Project	<b>IEEE 802.16 Broadband Wireless Access Working Group</b> < <a href="http://ieee802.org/16">http://ieee802.org/16</a> >	
Title	<b>Pilot allocations for 5,6,7,and 8 BS antennas</b>	
Date Submitted	<b>2004-11-04</b>	
Source(s)	Qinghua Li, Xintian Eddie Lin, Shilpa Talwar, Nageen Himayat <b>Intel Corporation</b>	<a href="mailto:qinghua.li@intel.com">qinghua.li@intel.com</a> Voice: +1-408-765-9698
Re:		
Abstract	Pilot allocations for 5-8 transmit antennas in optional FUSC and Band AMC	
Purpose	Adoption of proposed changes into P802.16e <del>Crossed out indicates deleted text,</del> <u><a href="#">underlined blue indicates new text change to the Standard</a></u>	
Notice	This document has been prepared to assist IEEE 802.16. It is offered as a basis for discussion and is not binding on the contributing individual(s) or organization(s). The material in this document is subject to change in form and content after further study. The contributor(s) reserve(s) the right to add, amend or withdraw material contained herein.

# Pilot Allocations for 5-8 Transmit Antennas in optional FUSC and Band AMC

Figure 251d—Pilot allocation for 5-antenna BS for the optional FUSC and the optional AMC zones.

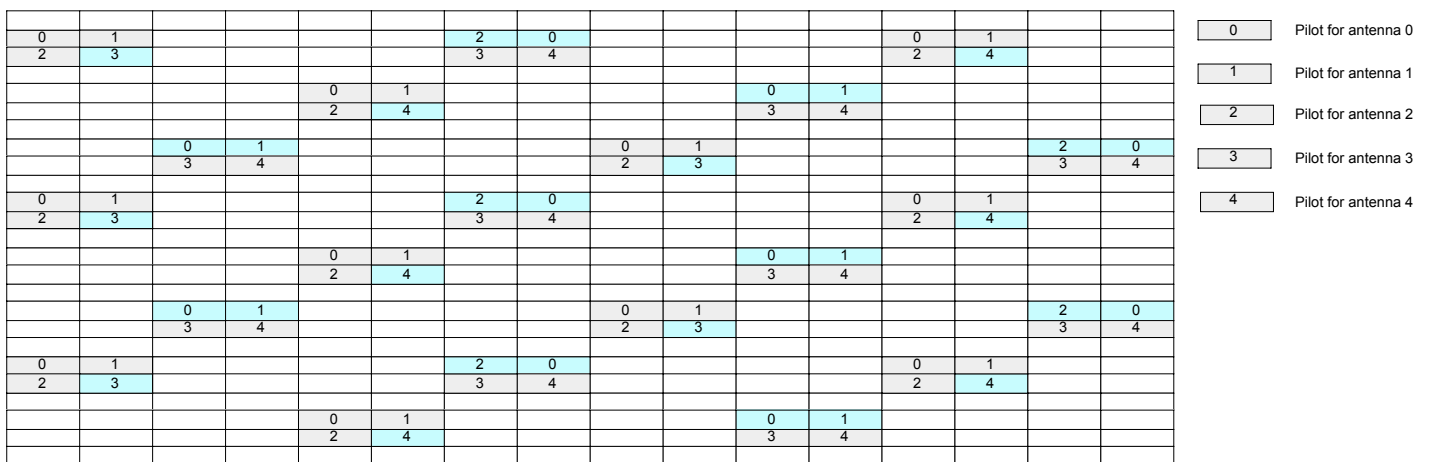
[Add the following text to section 8.4.8.3.1, 802.16e D5. ]

For 5-antenna BS, pilot pattern is shown in Figure 1. The pilot in gray is periodic with a frequency period of 9 subcarriers and a time period of 4 OFDM symbol durations. The pilot in light blue has a frequency period of 9 subcarriers and a time period of 8 OFDM symbol durations. The pilot density of each antenna except antenna 0 is 1/24 and the pilot density of antenna 0 is 1/18.

Figure 251e—Pilot allocation for 6-antenna BS for the optional FUSC and the optional AMC zones.

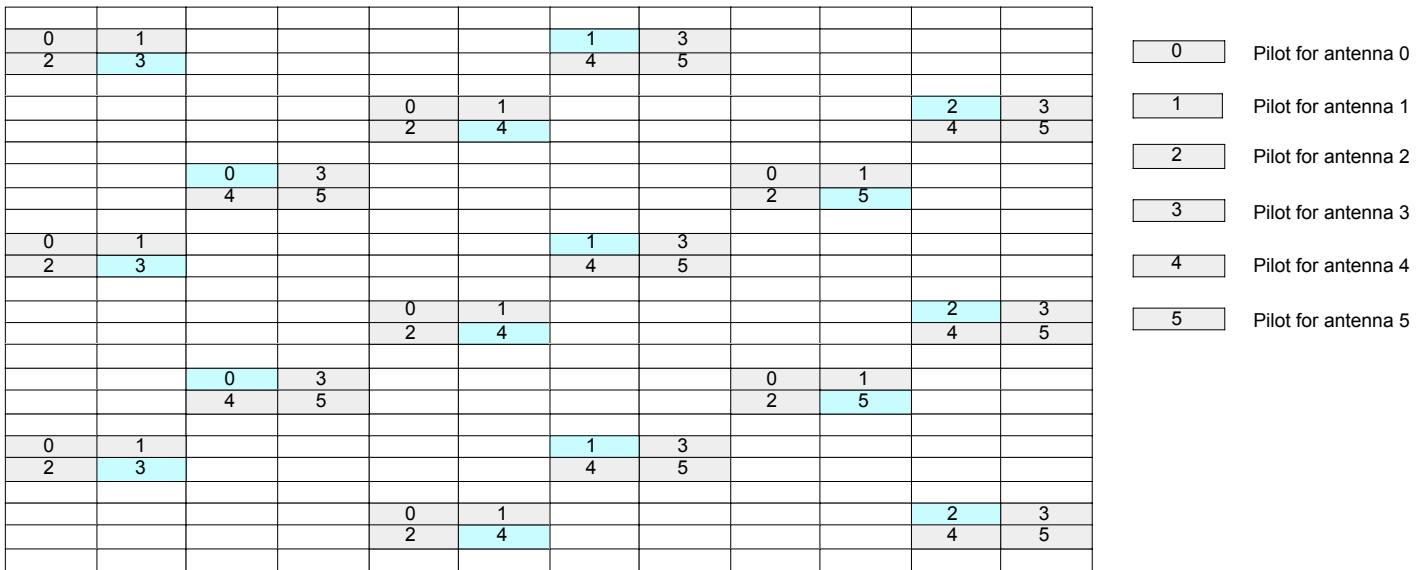
For 6-antenna BS, pilot pattern is shown in Figure 2. The pilot in gray is periodic with a frequency period of 9 subcarriers and a time period of 4 OFDM symbol durations. The pilot in light blue has a frequency period of 9 subcarriers and a time period of 8 OFDM symbol durations. The pilot density of each antenna is 1/24.

Figure 251f—Pilot allocation for 7-antenna BS for the optional FUSC and the optional AMC zones.

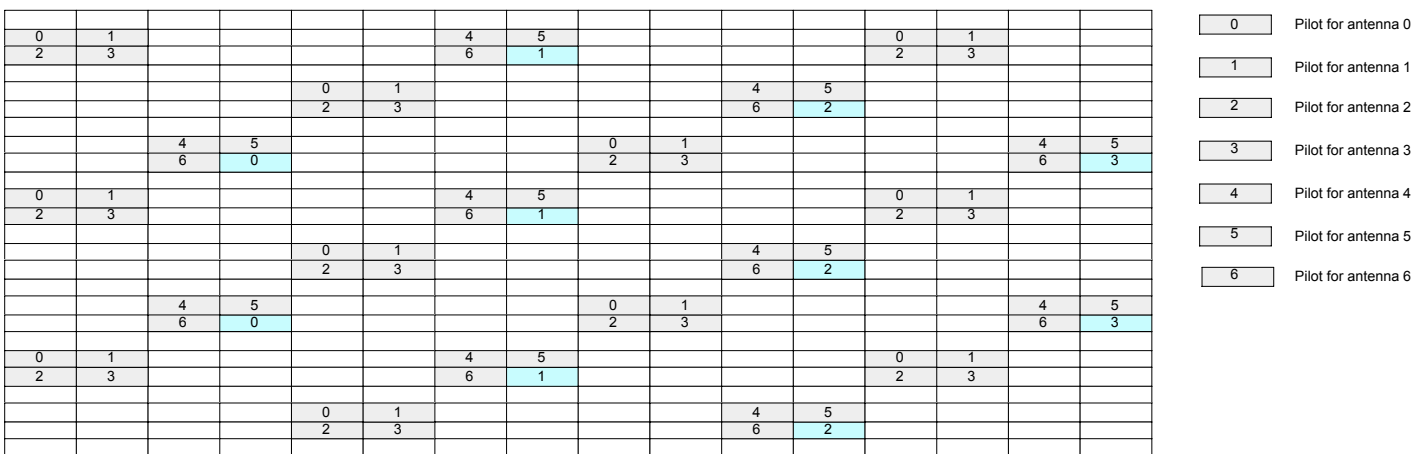
For 7-antenna BS, pilot pattern is shown in Figure 3. The pilot in gray is periodic with a frequency period of 9 subcarriers and a time period of 4 OFDM symbol durations. The pilot in light blue has a frequency period of 9 subcarriers and a time period of 28 OFDM symbol durations. The pilot density of each antenna is 2/63.

[Figure 251g—Pilot allocation for 8-antenna BS for the optional FUSC and the optional AMC zones.](#)

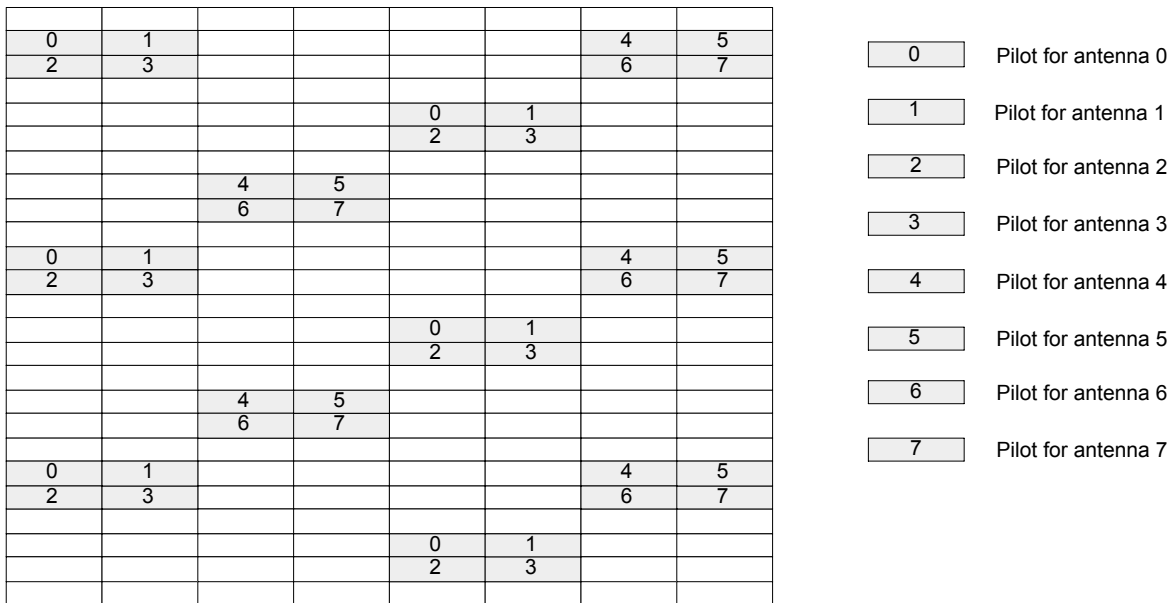
For 8-antenna BS, pilot pattern is shown in Figure 3. The pilot in gray is periodic with a frequency period of 9 subcarriers and a time period of 4 OFDM symbol durations. The pilot in light blue has a frequency period of 9 subcarriers and a time period of 8 OFDM symbol durations. The pilot density of each antenna is 1/36.
